**ALA WAI CANAL PROJECT
O'AHU, HAWAII**

**DRAFT FEASIBILITY STUDY REPORT WITH INTEGRATED
ENVIRONMENTAL IMPACT STATEMENT**

**APPENDIX G
PUBLIC AND AGENCY INVOLVEMENT**

Figure 1 - Waiakeakua Stream Gage/Flume During Normal/Moderate Rainfall Conditions

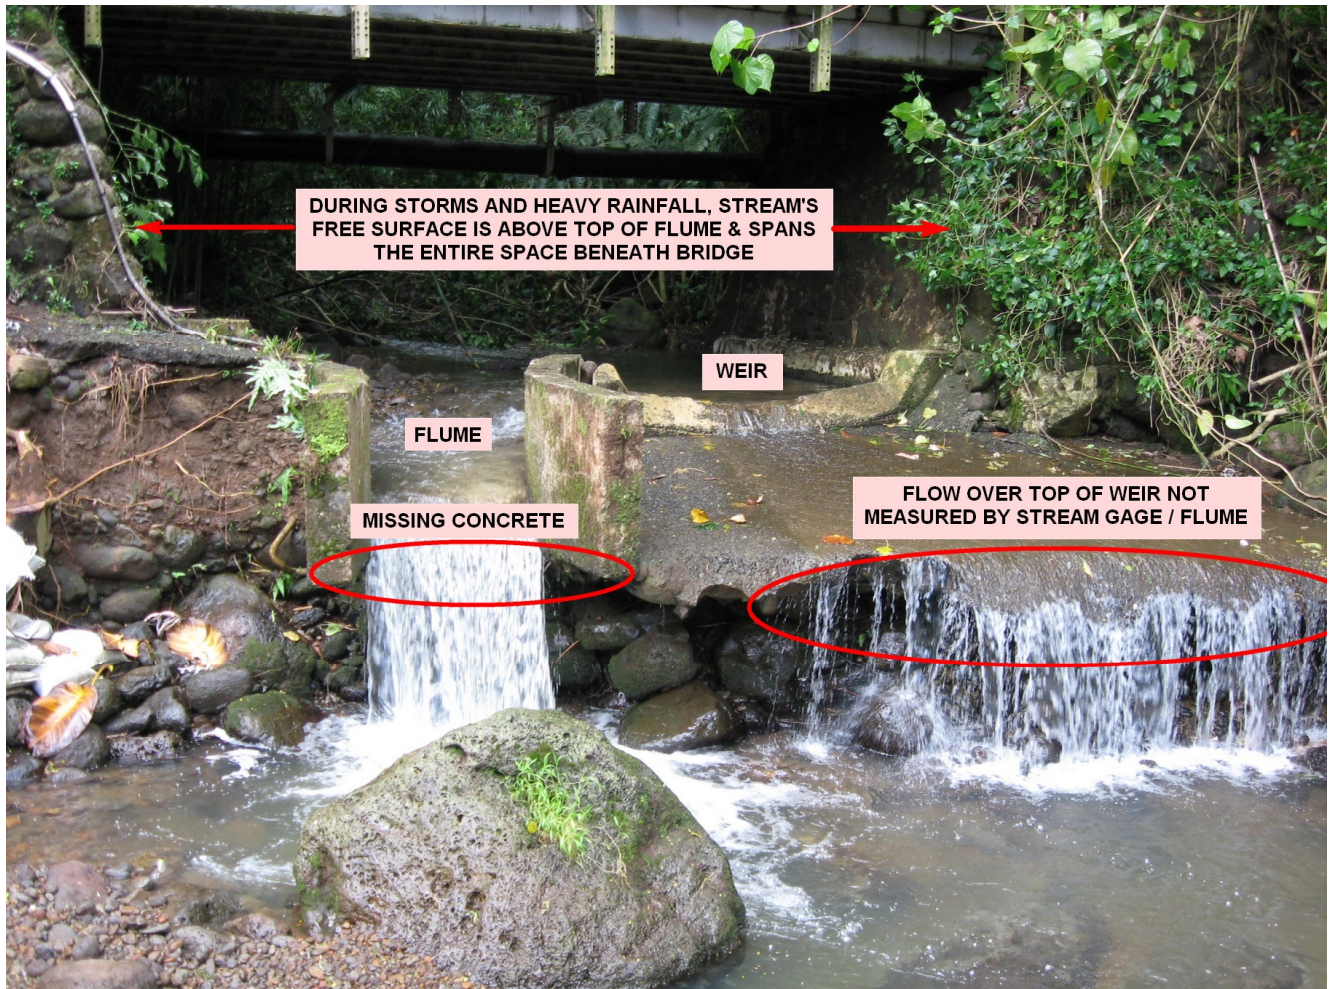
Section 3.2 Stream Flow Gages -“Historic stream gage records were used to develop sub-basin analyses for the HEC-HMS model.”: Based on my visual observations of the Waiakeakua Stream over the past 27 years, it is apparent that the Waiakeakua Stream gage (#16240500) with its existing concrete flume are undersized and unsuitable for measuring stream flow rates during storms or even moderate rainfall. The existing flume is small and only spans a portion of the stream cross section. Consequently, this stream gage and flume are only suitable for measuring low flows during dry weather and not high flows during storms when most of the stream flow is above and to the sides of the flume. Even during periods of normal to moderate rainfall, the stream flows over the top of the adjacent parallel weir, and this portion of the stream flow is not registered by the stream gage and flume. See Figure 1 below. Also, the concrete flume is severely deteriorated as evidenced by missing chunks of concrete near its throat and diverging section.

During storms, most of the stream flow is above and to the sides of the existing flume as shown in Figure 2 below. Therefore, the stream flow measurements for the Waiakeakua Stream will be highly unreliable (too low). A similar situation also exists for the nearby Waihi Stream gage.

Figure 4 – Partial Site Plan on Drawing #C-302 from Section A2 of Appendix A

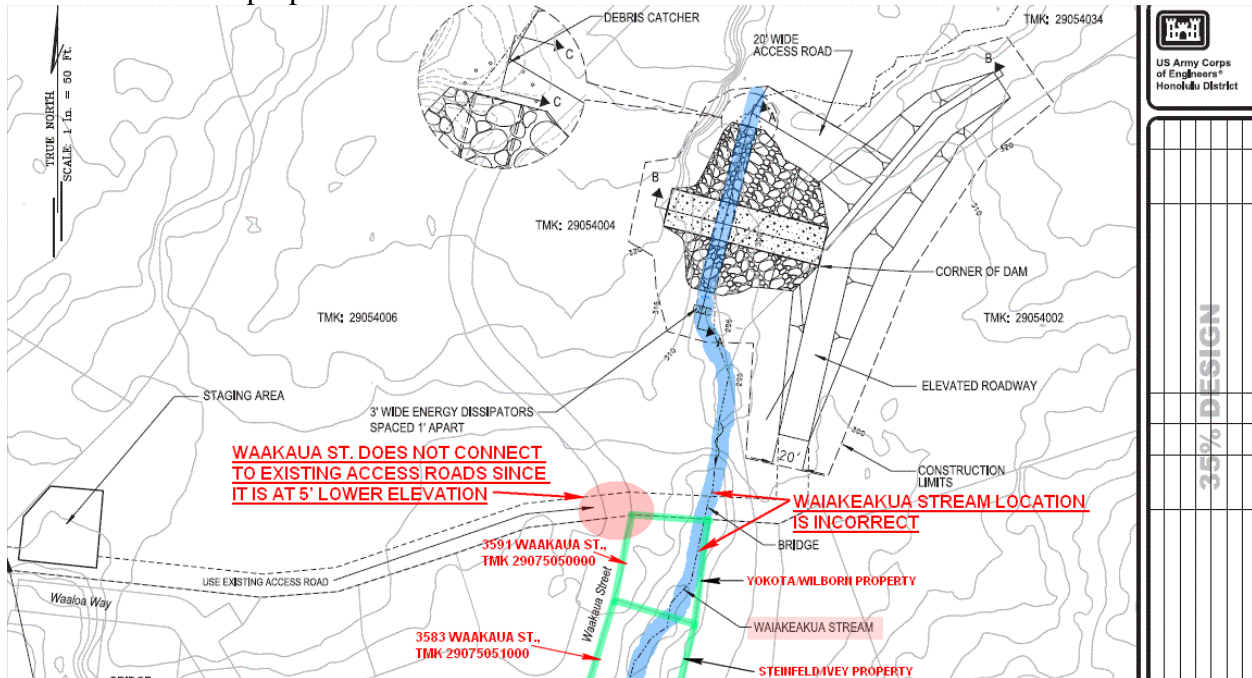
Waiakeakua Debris And Detention Plan And Sections, Sheet # C-302 (35% Design), Section A2 – Aluminum Arch Culvert: The proposed design drawing shows the arch culvert will be 4 ft. high X 12 ft. wide and be constructed of corrugated aluminum plate. The upper side of the culvert will be in direct contact with soil and rock from the earthen dam while the underside will be partially submerged or be subject to splashing from the stream. Aluminum is an anodic metal that is subject to accelerated corrosion under such conditions. It is a well known fact that aluminum is a highly corrodible metal and is even used as sacrificial anodes in cathodic protection systems to protect buried or submerged metal structures and pipes. Therefore, it is strongly recommended that aluminum plate be replaced with a more suitable material that can better resist corrosion. Type 316 and 316L stainless steels are some possible replacement options. Another possibility is a concrete culvert or channel.

Waiakeakua Debris And Detention Plan And Sections, Sheet # C-302 (35% Design), Section A2 –Debris Catchment: The proposed debris catchment design includes a series of vertical 8" diameter pipes embedded in concrete footings. It is apparent that this design is not sufficiently strong to resist and survive the impact from the numerous large boulders that are swept quickly downstream during storm conditions. For example, behind our property there is a 5-ft long X 2 ft wide X 9" thick concrete slab that is sandwiched between a pair of 5-ft. diameter boulders that appeared in the middle of the stream after a storm several years ago. See photo in Figure 3 below. The swift current in the Waiakeakua Stream is very strong and deep during storms, and can rapidly transport heavy boulders and other debris downstream. During severe storms, the collisions of the boulders in the stream create loud noises equaling that of thunder. It is unlikely that the proposed debris catchment will be able to withstand the impact of such boulders under such stream flow conditions. Also, the longevity of the steel pipes is also a concern especially if they are to be constructed of carbon or galvanized steel which won't last very long under the wet and corrosive environment.

Waiakeakua Debris And Detention Plan And Sections, Sheet # C-302 (35% Design), Section A2 – Flow Over Emergency Spillway if Culvert Gets Plugged: In view of the large boulders and debris flowing in the stream and the questionable longevity of the proposed arch culvert, it is strongly recommended that the consequences of the entire peak storm flow over the top of the earthen dam be evaluated. In other words, the design should include consideration to the real life situation when all peak flow from the 100-year storm flows over the top of the earthen dam with no flow from its (plugged) culvert. Of particular concern is the possibility of flooding to residential homes and properties along the stream on Waakaua Street that are immediately downstream of the proposed earthen dam. Based on grading plan drawings for the Manoa Shangri-la neighborhood, the elevations of these properties range between 286’ to 299’ elevation as compared to 317’ elevation of the bottom of the emergency spillway. This is a serious concern for obvious reasons.

Waiakeakua Debris And Detention Plan And Sections, Sheet # C-302 (35% Design), Section A2 – Site Plan: There are several errors on the partial site plan for Waakaua Street and the location of the Waiakeakua Stream relative to residential properties in our neighborhood. See marked up partial plan in Figure 4 below. The City & County of Honolulu’s printed tax map (Figure 5 below) is also attached for reference. These errors should be corrected since they might affect the location of the proposed debris catchment and earthen dam.

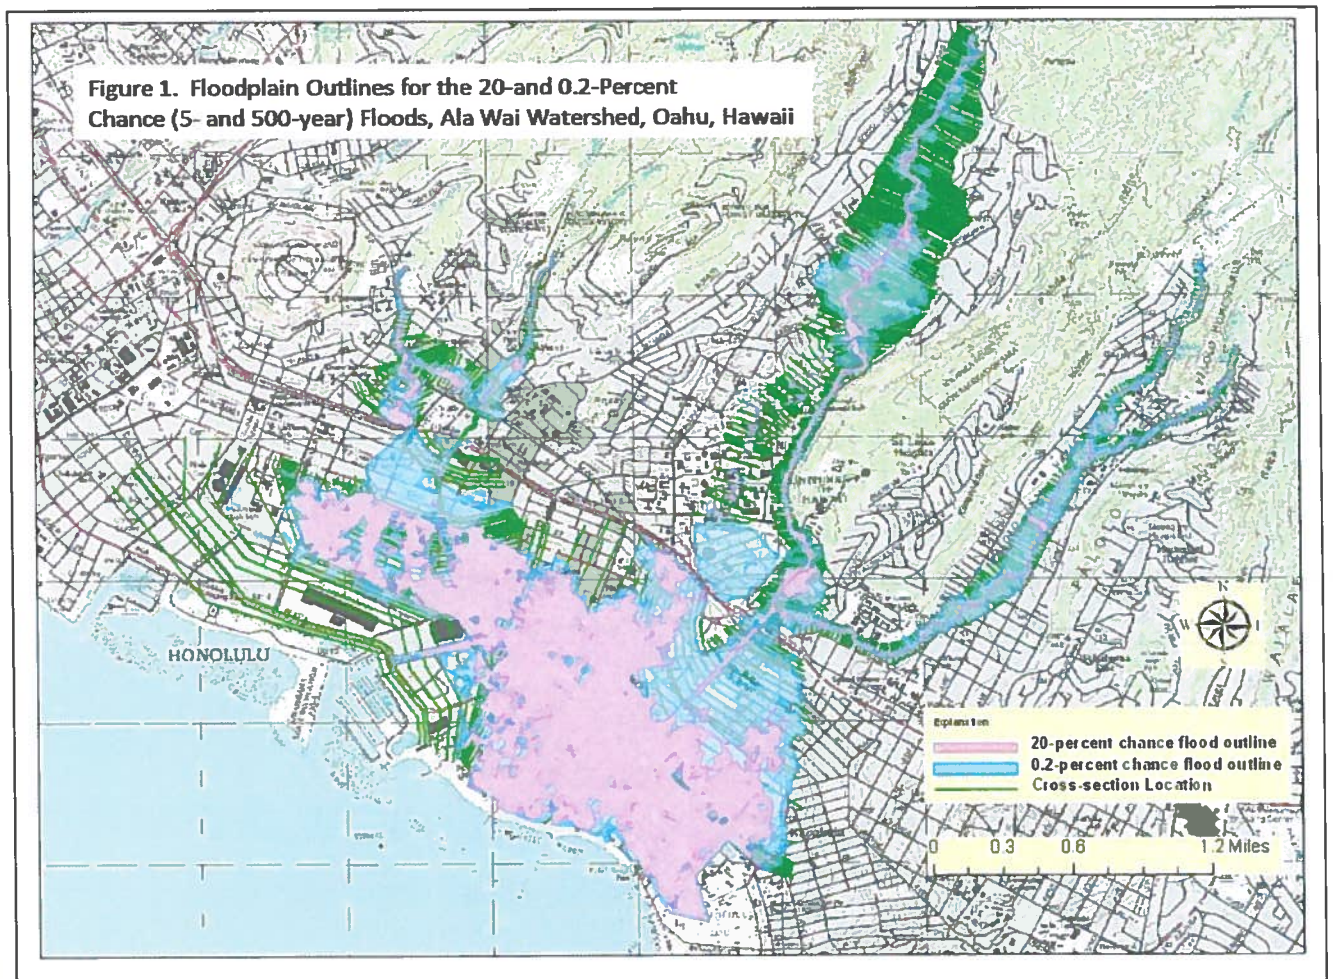
We believe the Thiessen Polygons diagrams are inaccurate because around the perimeter of the Ala Wai Watershed because no rain gauges are located outside of the watershed. There also seems to be several Polygons without rain gauge stations to reference.

We believe the description, layout, maps, pictures, of each rainfall gauge and stream flow gauge should be shown. The equipment make, model, year, accuracy, calibration and certification dates listed for each rainfall gauge and stream flow gauge. Are there any protections in place to insure that the data is accurate. There are instances where you toss out flow reading because they don't add up. This should be an indicator that the stream flow gauge may be inaccurate or malfunctioning or be calibrated incorrectly as stated in Section 4.12
